BID ADDENDUM NO. 5

October 08, 2018

Johnson Student Center Building Demolition, Increment 1 (Demolition) and Increment 2

RANCHO SANTIAGO COMMUNITY COLLEGE DISTRICT
SANTA ANA, CA

Sheet L5.50 – Hardscape Details:

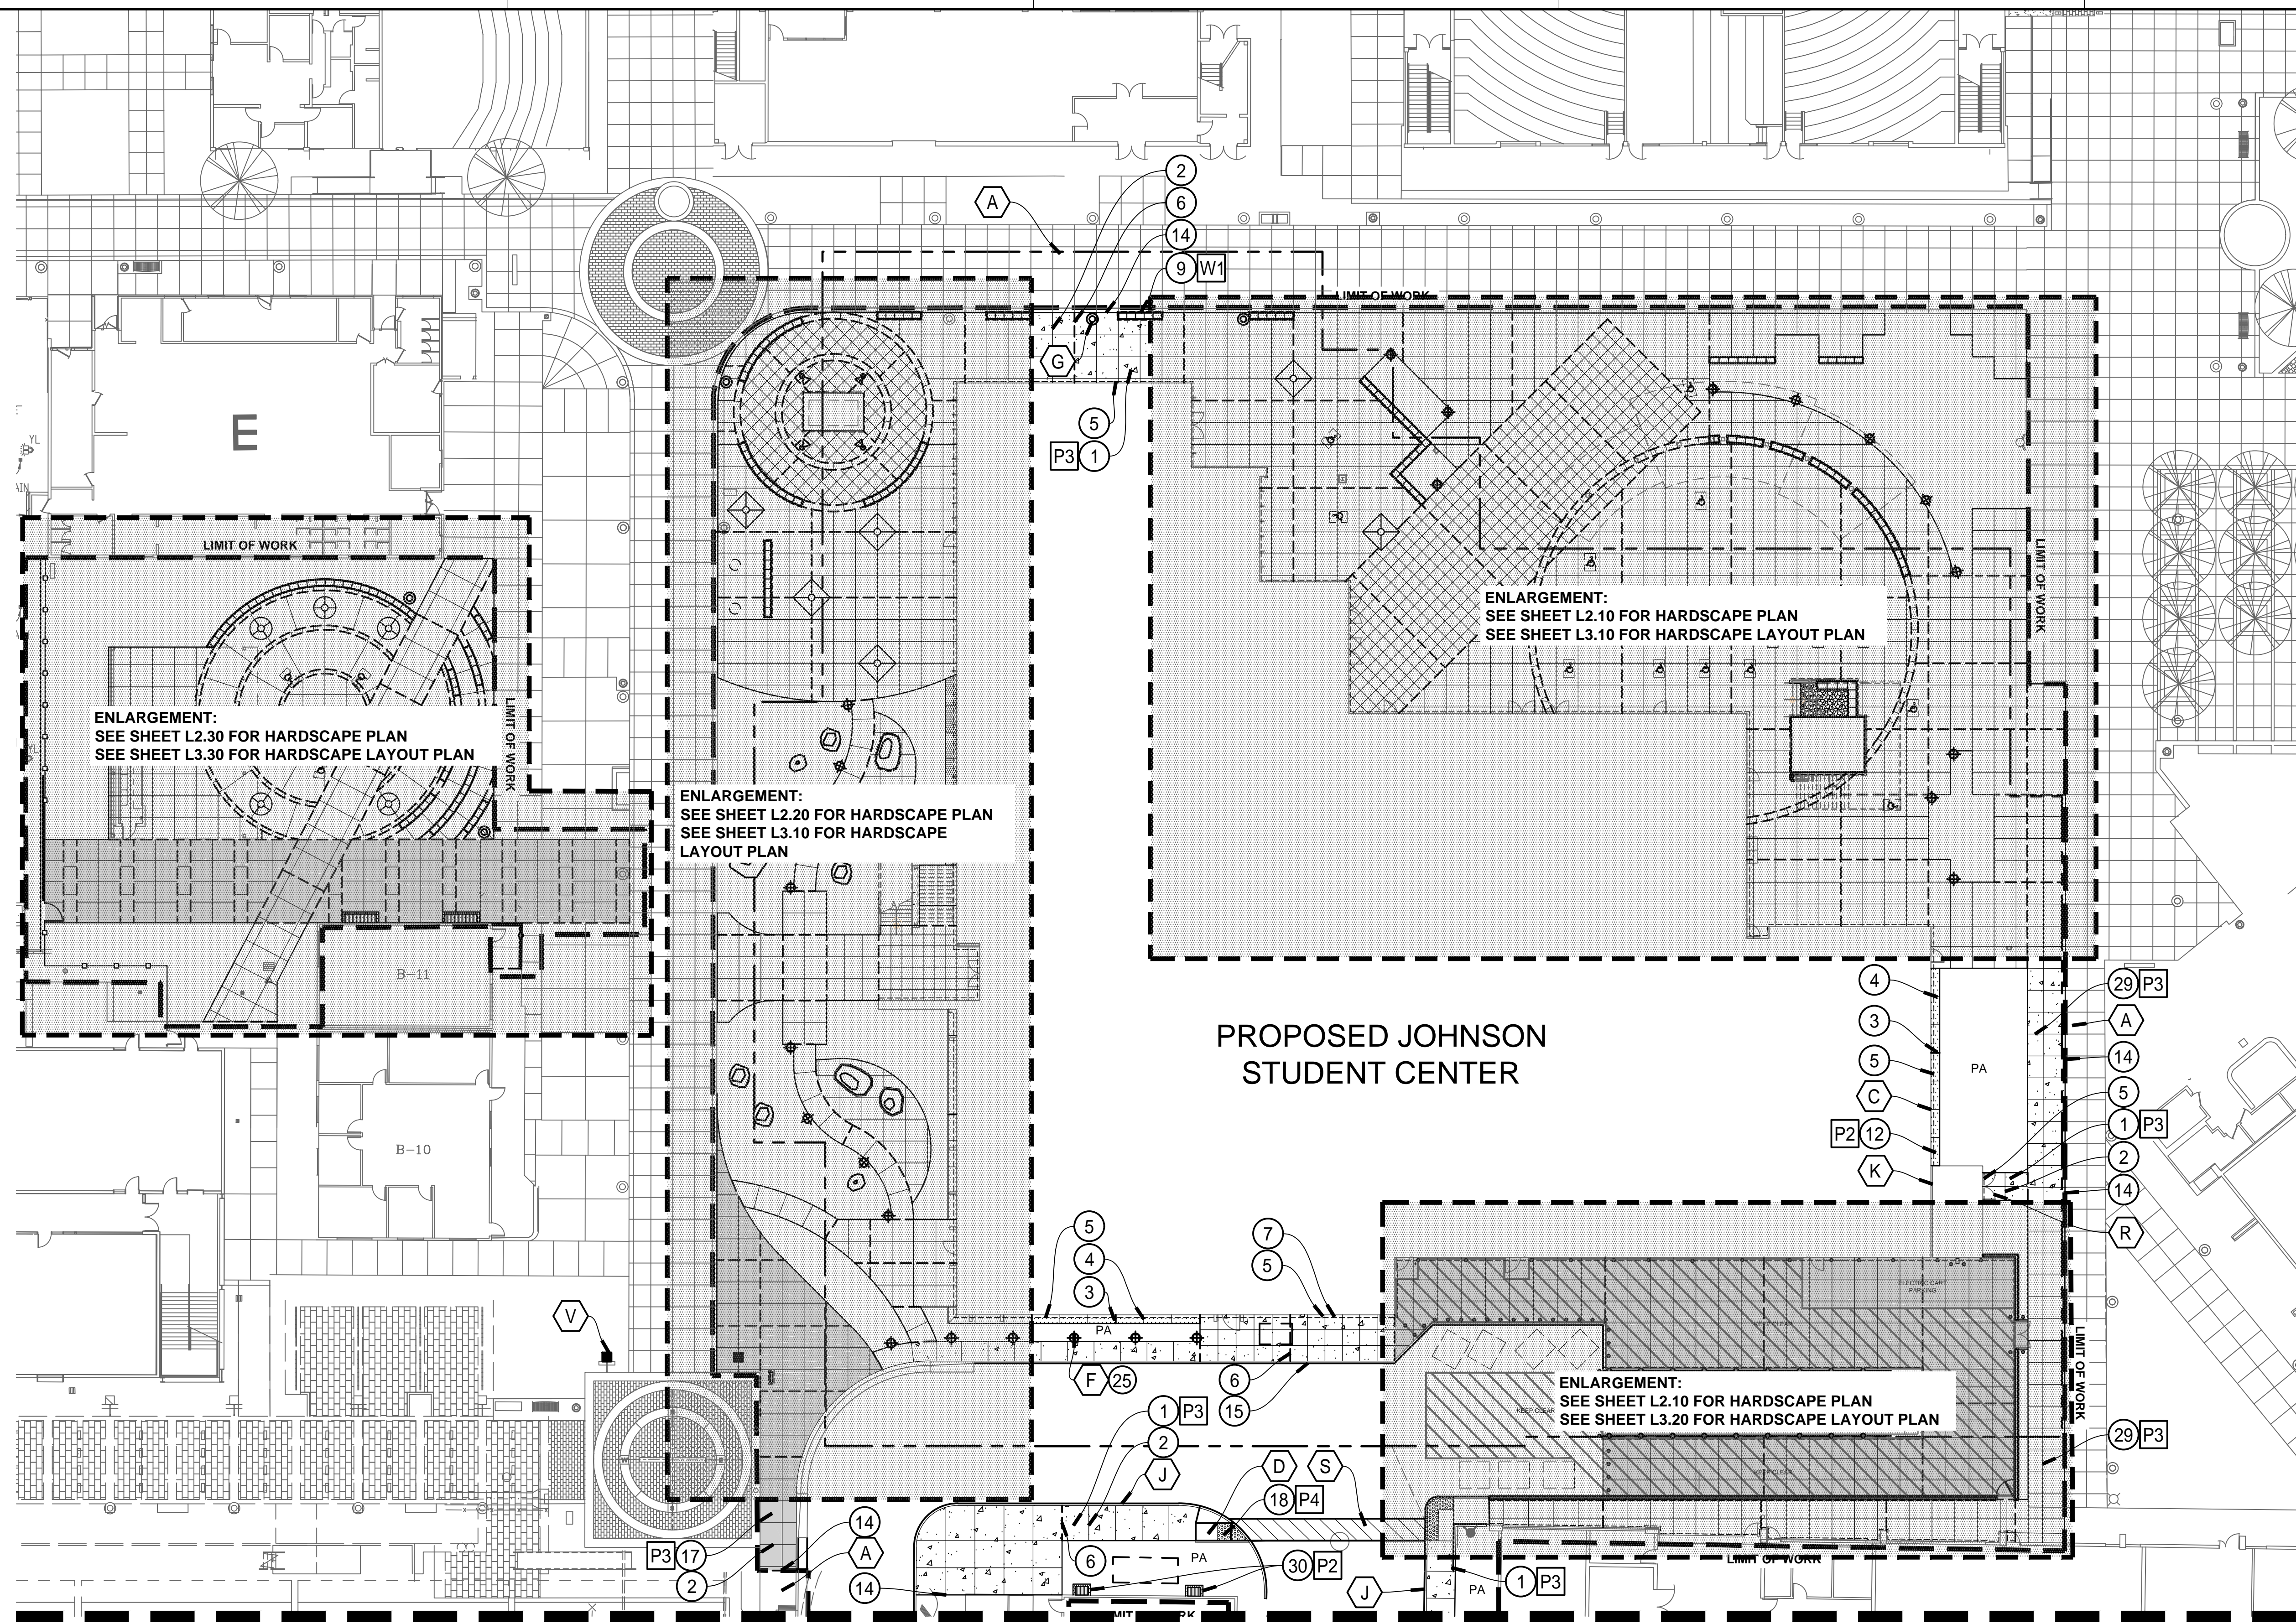
- Detail 'A': Removed Color and Finish from detail. Added reference back to Fence Schedule for color and finish.
- Detail 'B': Removed Color and Finish from detail. Added reference back to Fence Schedule for color and finish.
- Detail 'C': Removed Color and Finish from detail. Added reference back to Fence Schedule for color and finish.
- Detail 'D': Removed Color and Finish from detail. Added reference back to Fence Schedule for color and finish.
- Hardscape Notes: Omit Note 'B', not Applicable.

Sheet L9.10 – Planting Plan:

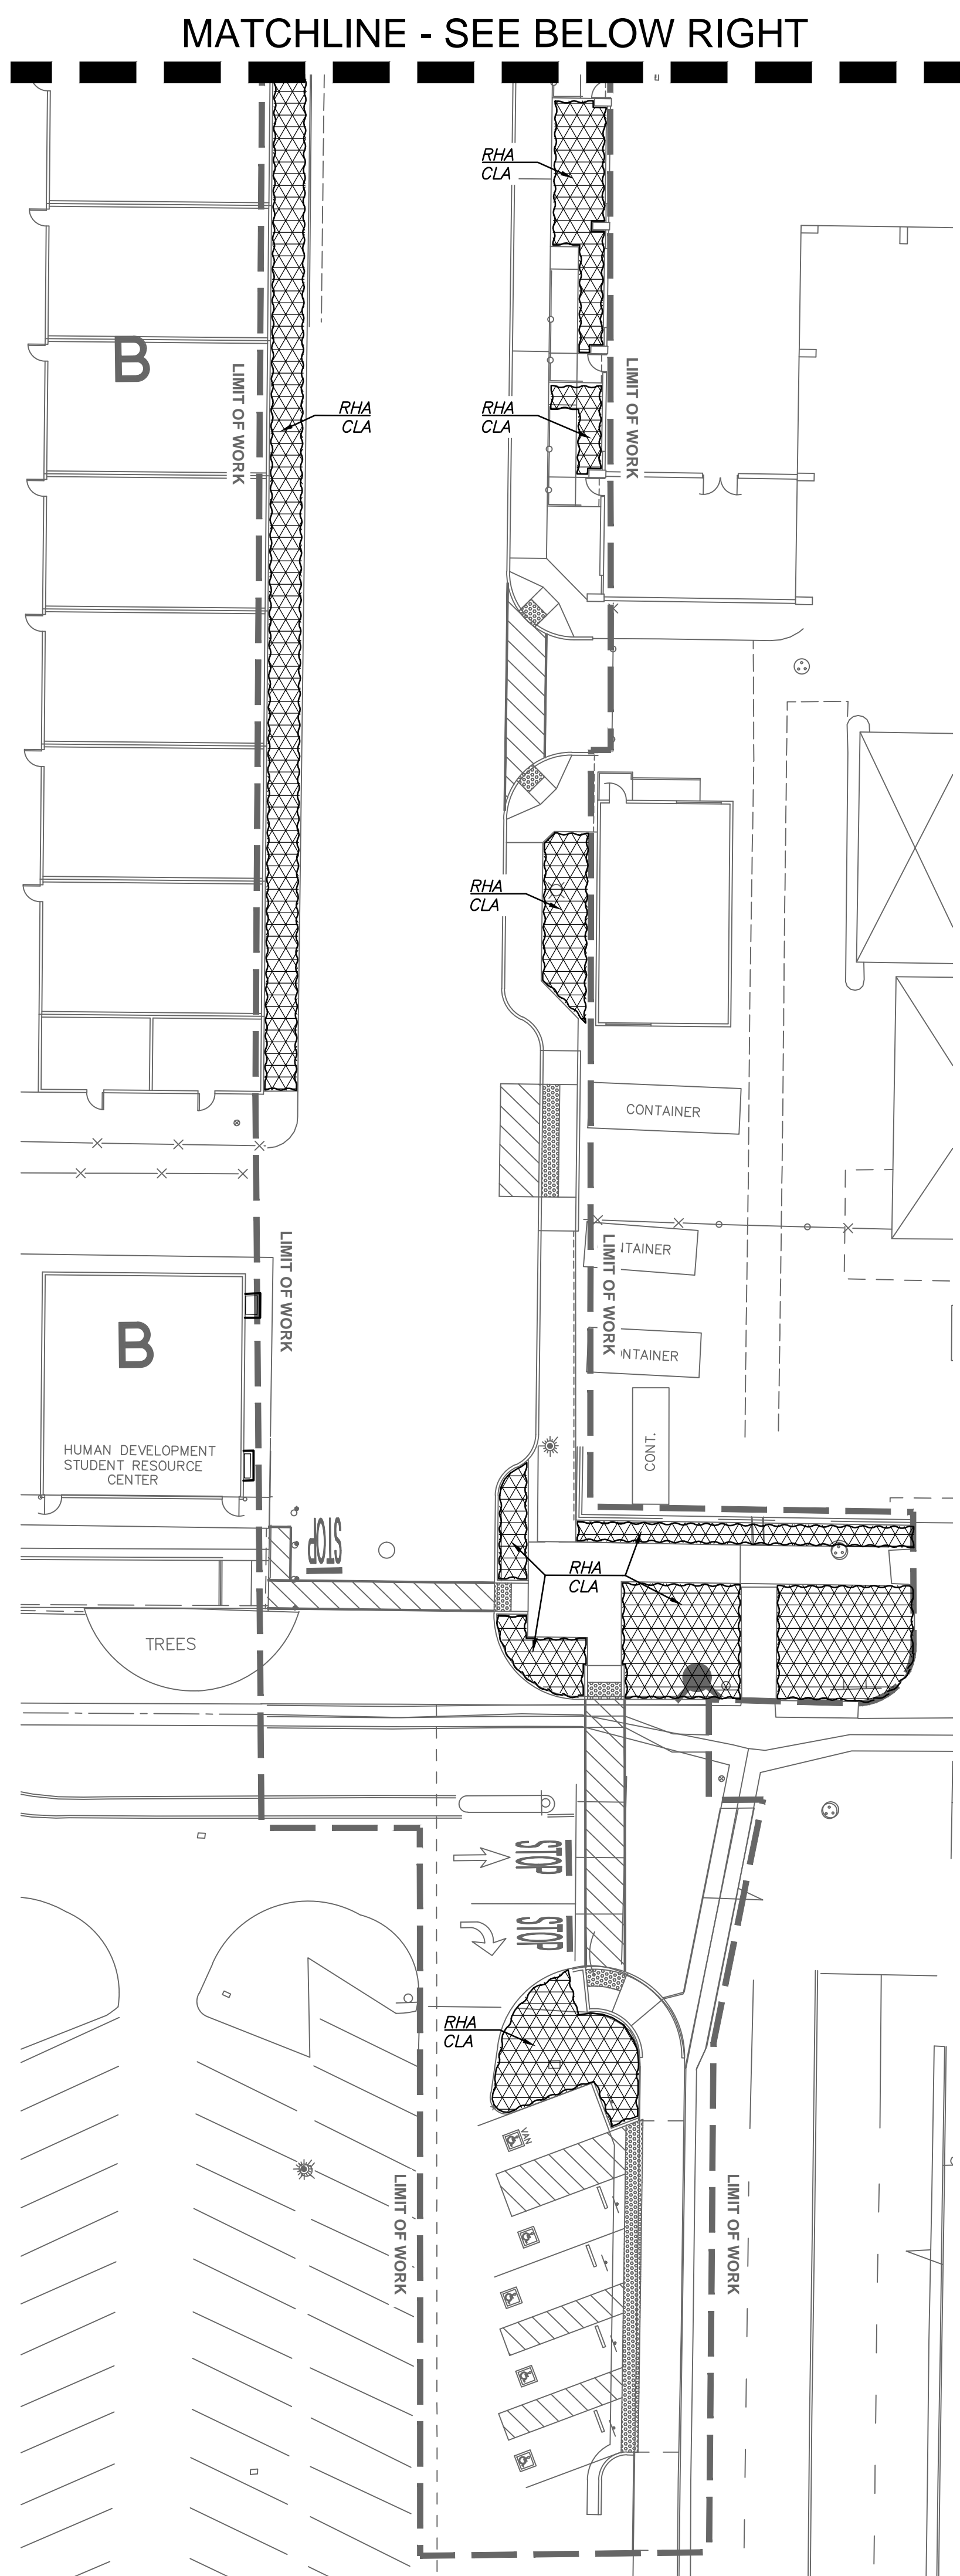
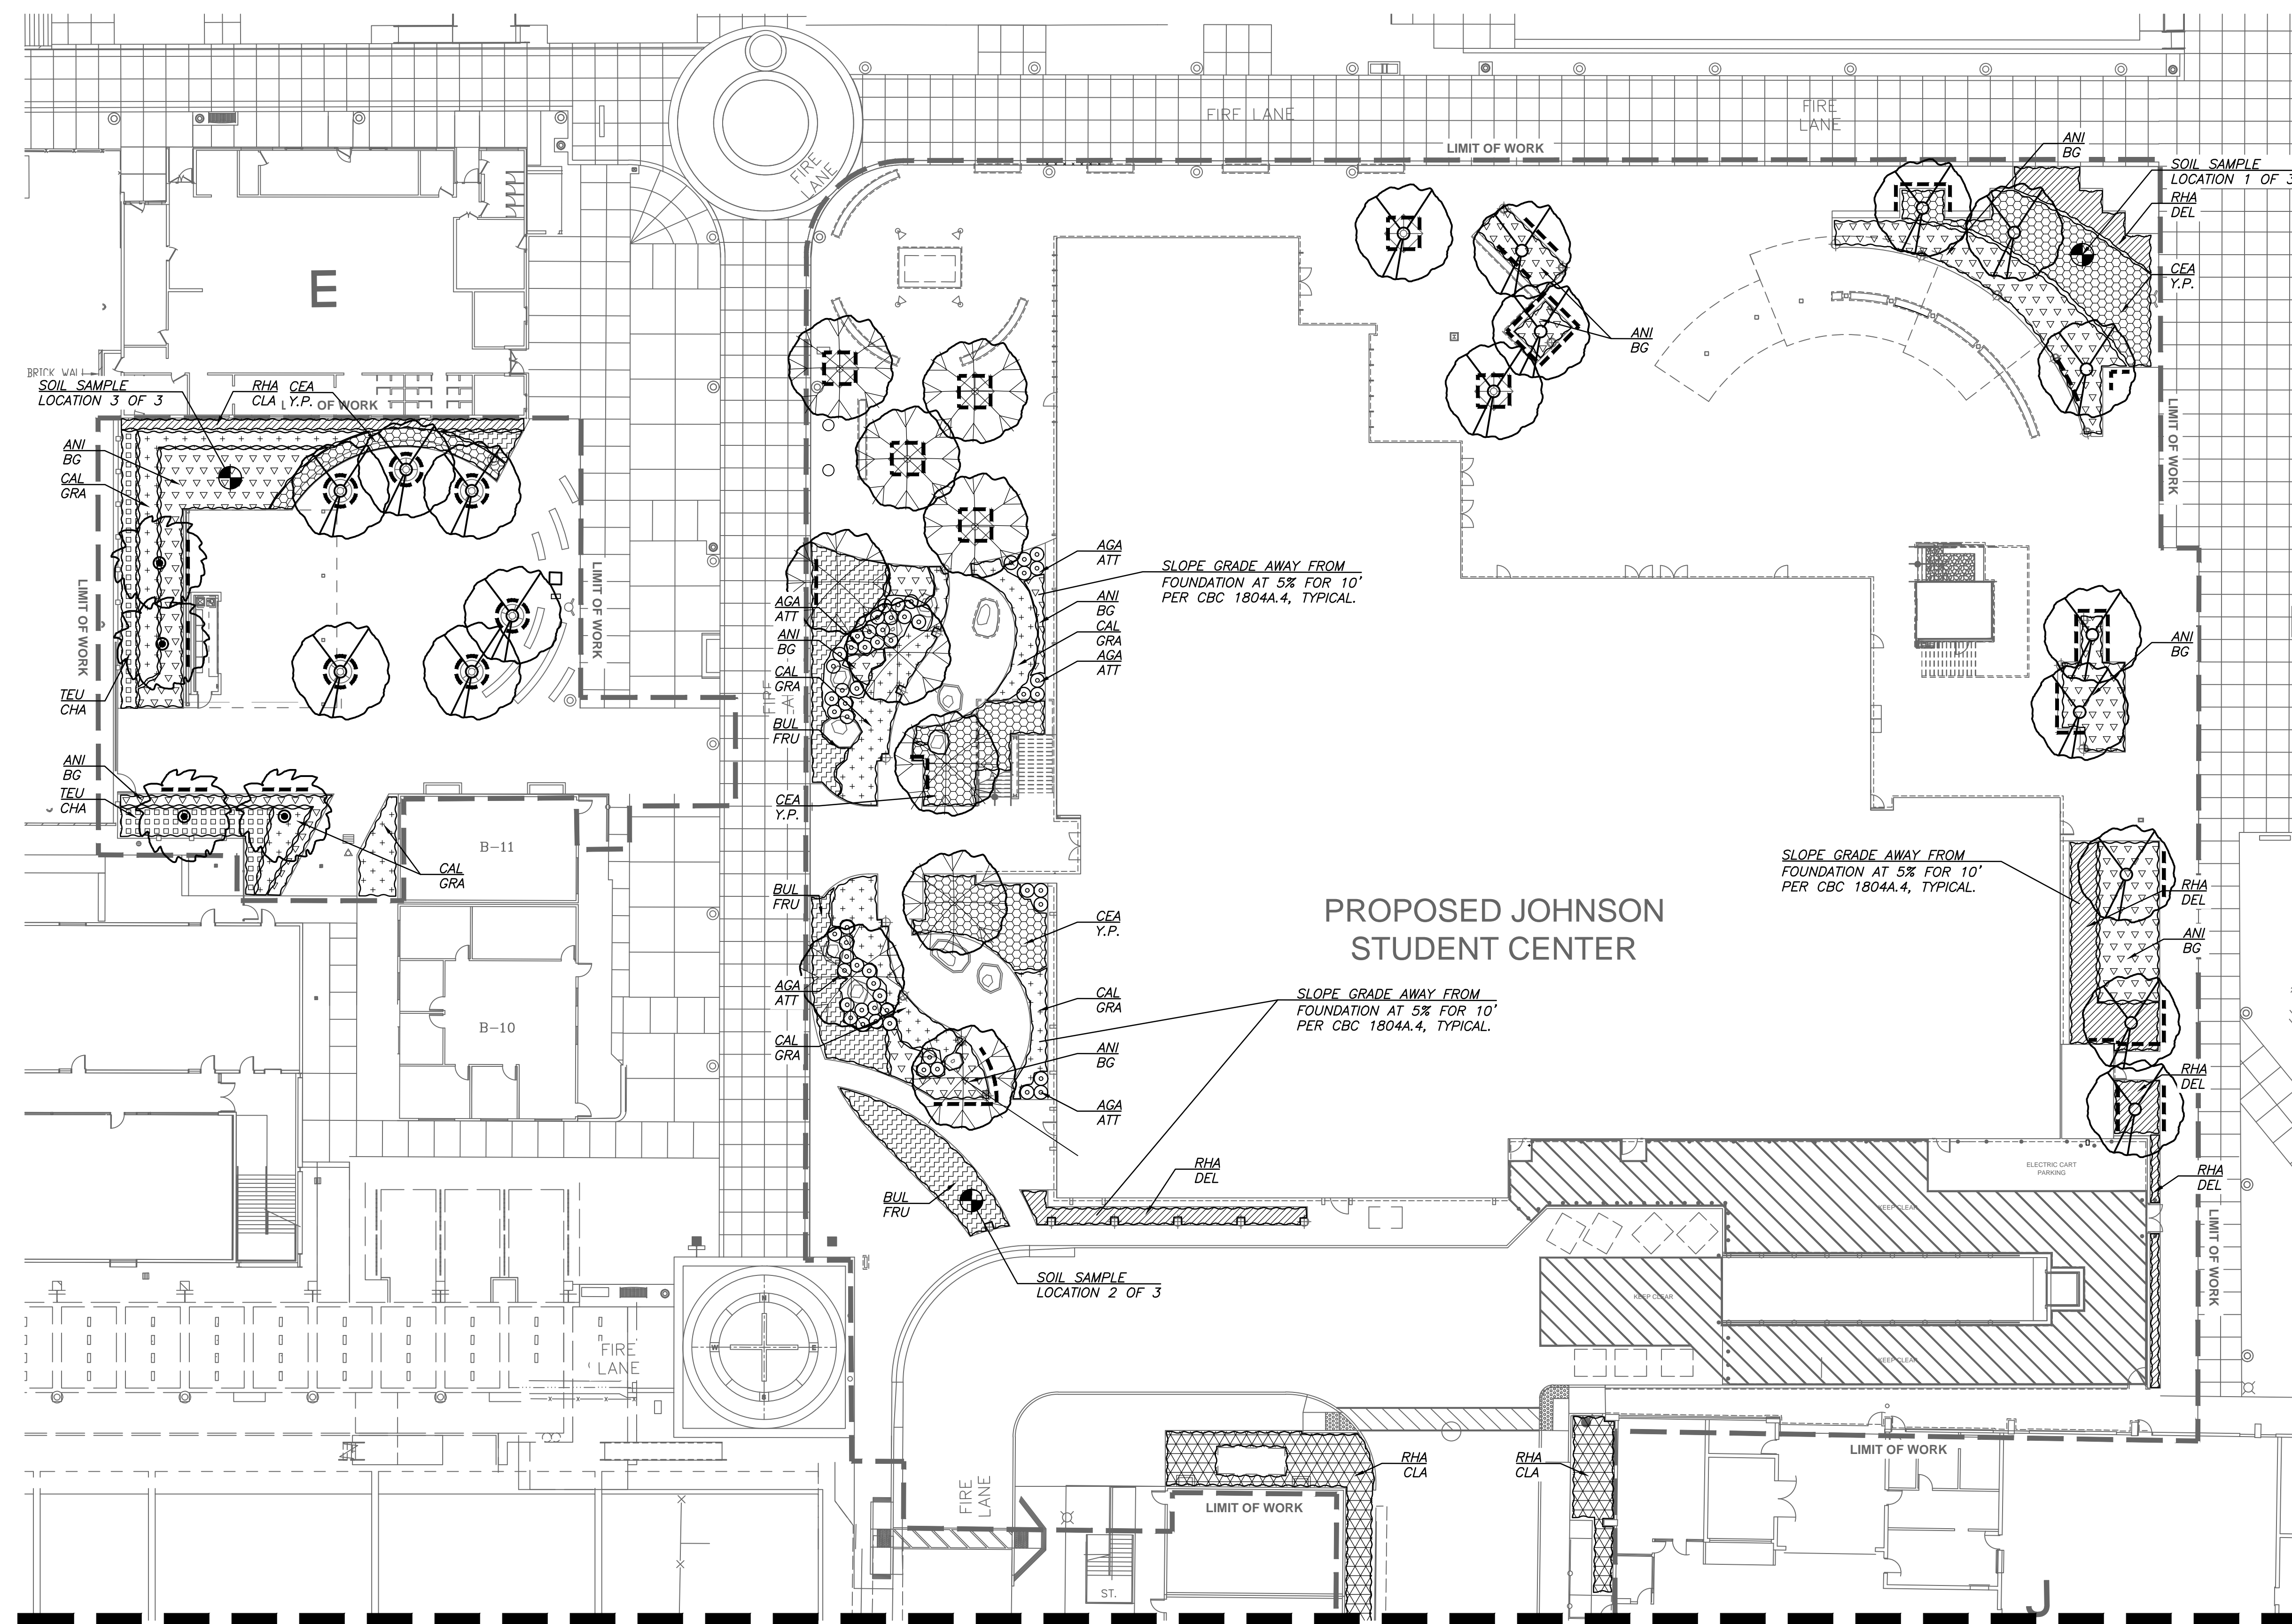
- Revised quantity of Honey Mesquite trees
